TO: Jessica McCallum, Kimley Horn
FROM: BrieAnna Simon, Associate Planner
DATE: November 8, 2021
SUBJECT: Douglas 234 F6 AMD 1 L3 – McDonalds (SP21-067)
Review Comments v2

DOUGLAS 234 FILING NO. 6, LOT 3

SITE PLAN

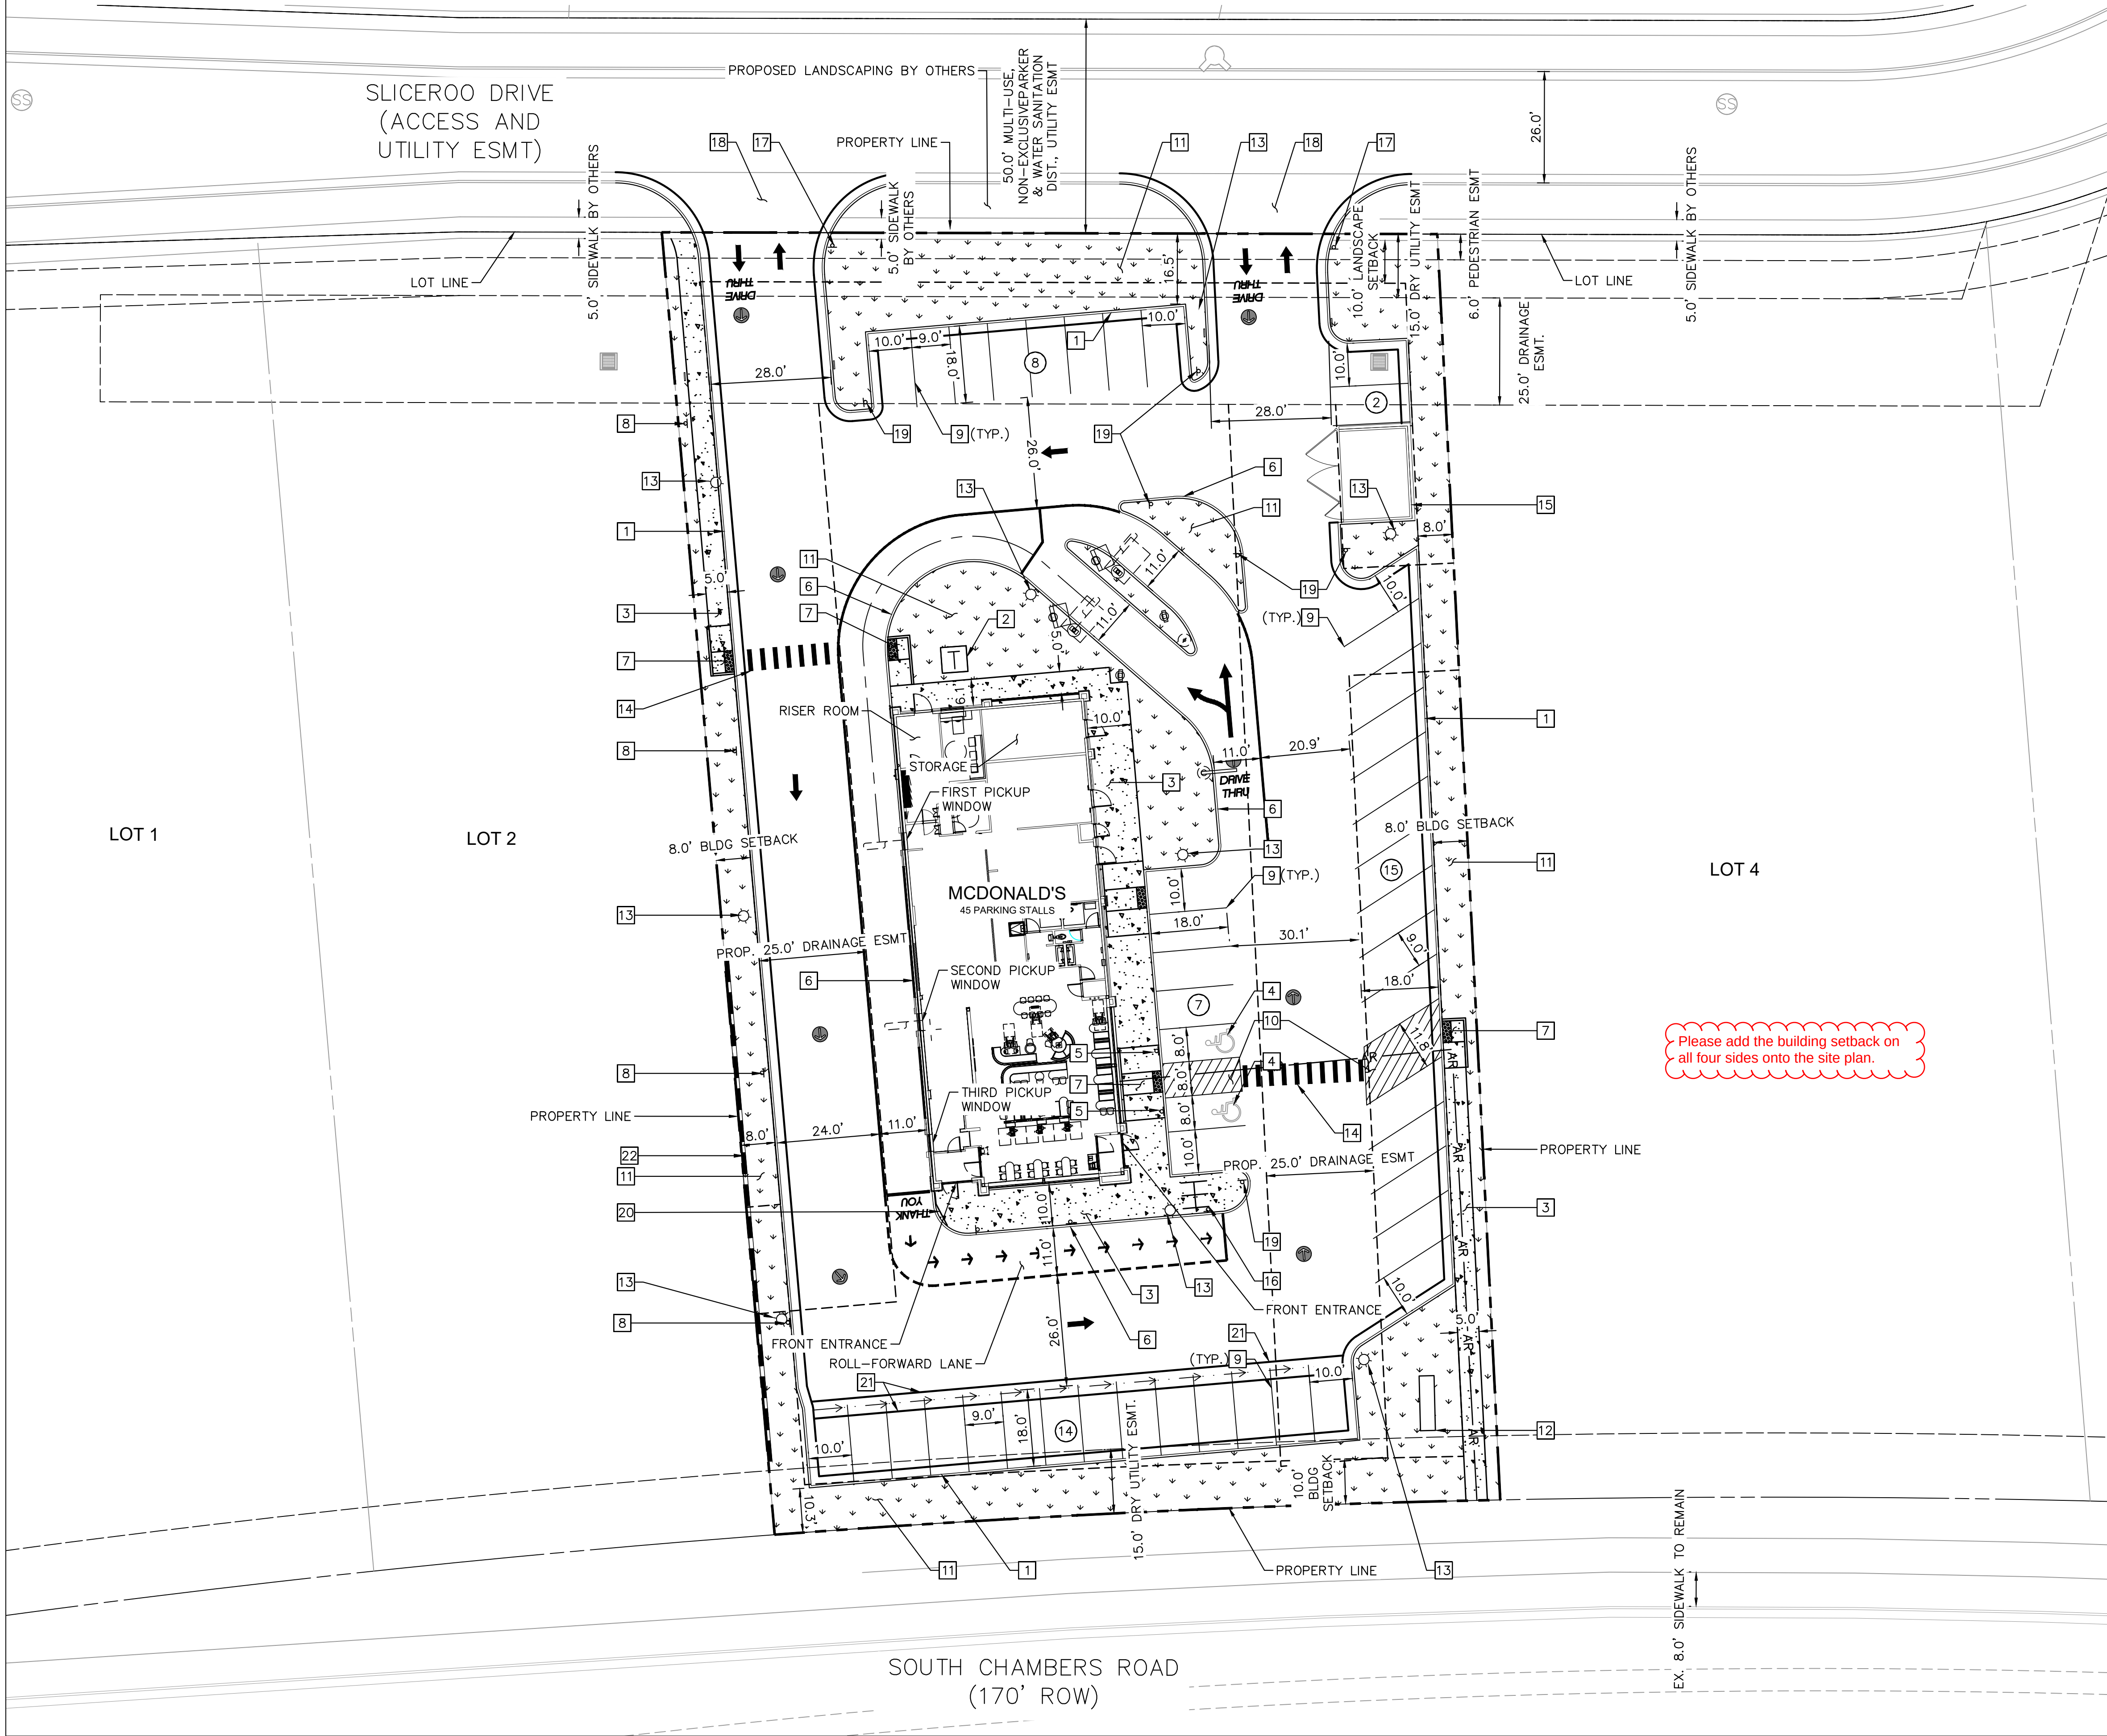
Please provide a light pole detail and indicate how height is being measured.

Are wall lights being provided? There are no wall lights shown in the Luminaire Schedule. Please adjust accordingly.

Per Section 13.10.140 for pedestrian safety and orientation, medium activity lots the maximum Uniformity Ratio (average to minimum) is 3:1. Please adjust accordingly.

Per Section 13.10.140 for pedestrian safety and orientation, medium activity lots the maximum Uniformity Ratio (maximum to minimum) is 10:1. Please adjust accordingly.

- Please add setbacks for all luminaires.
- Per Section 13.10.140 the setbacks from
- the property line shall be at least equal to
- the total height of the luminaire.

Please adjust labels to the values do not over lap on entire plan.

There are still large areas of the plan that foot candles have not been provided. Staff has highlighted a few of these areas in blue. Please provide additional values to ensure the lighting code has been met. Additional comments may still be provided on the next referral as all values have not been provided.

1 FRONT ELEVATION (WEST)
1/4" = 1'-0"

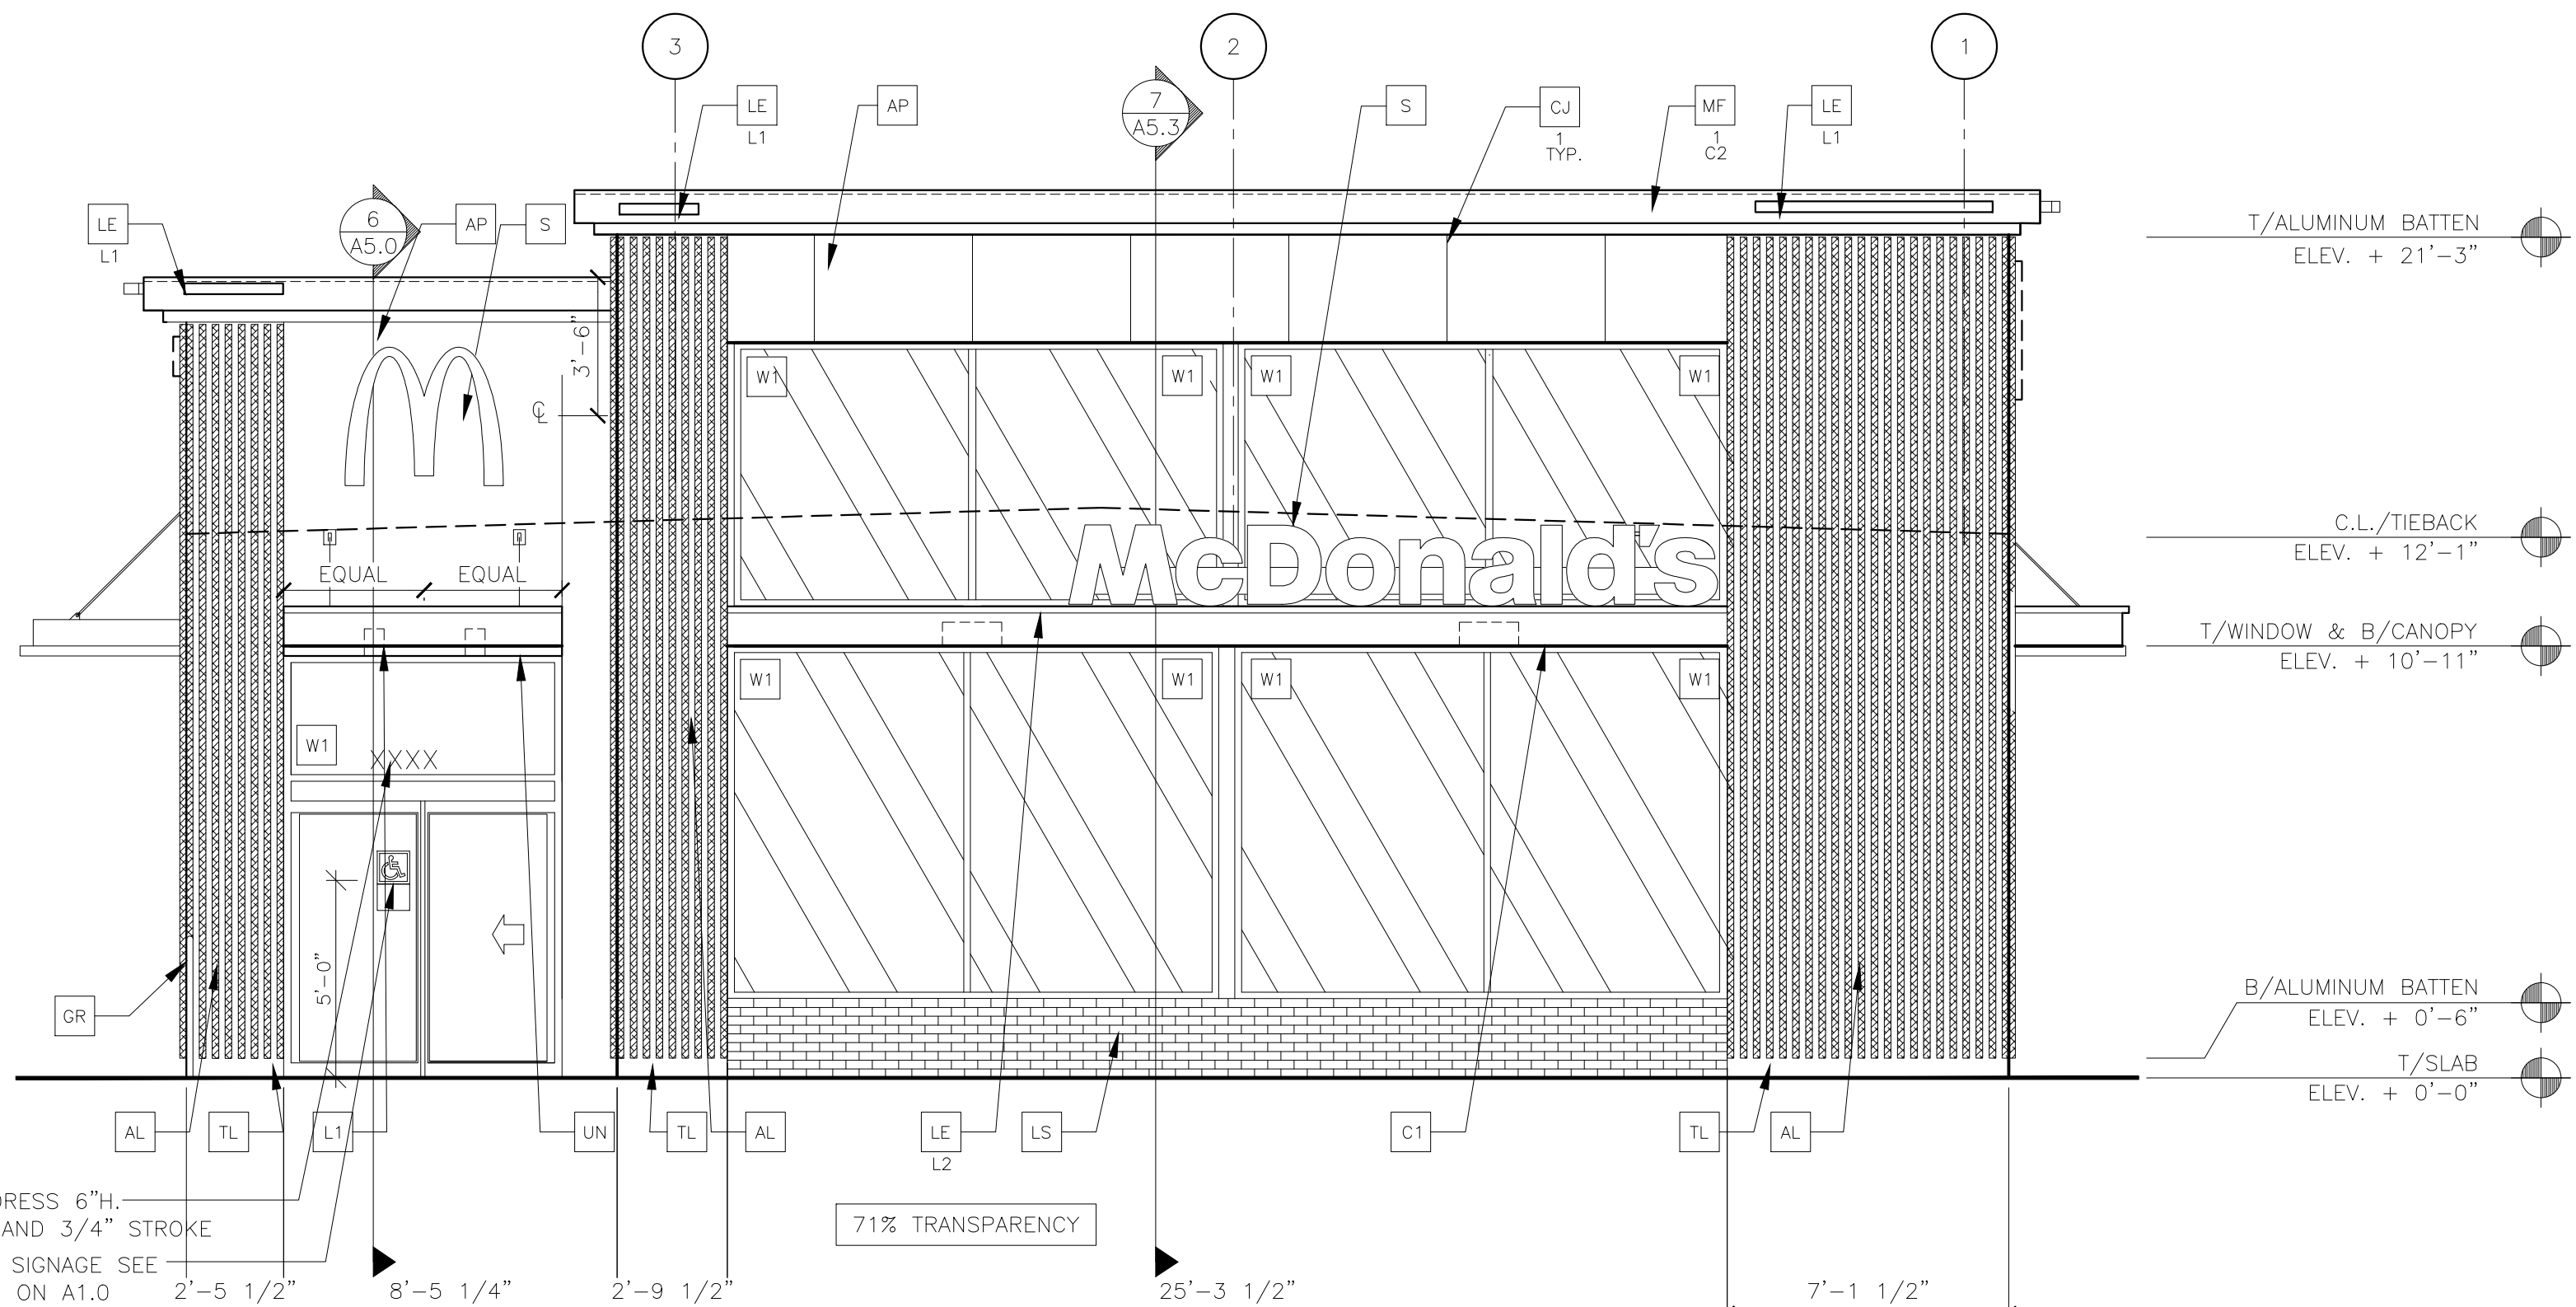
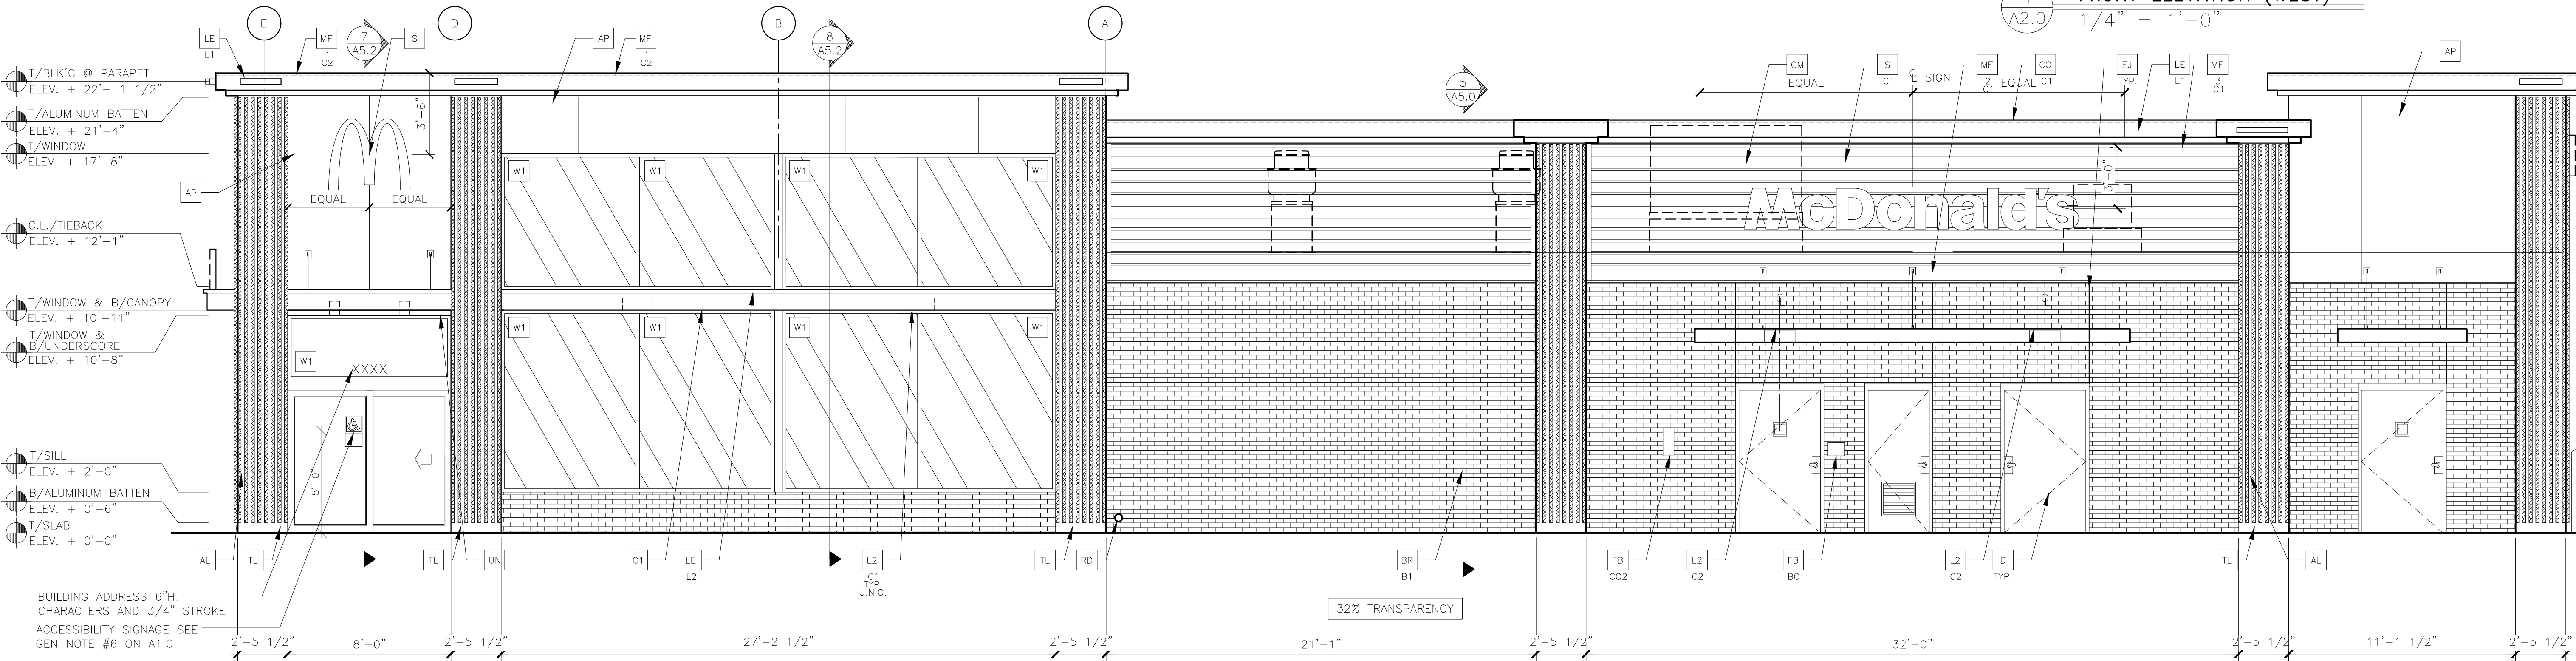
Where will the electrical panels be located on the building? This will need to be painted to match the building and screened with landscaping.
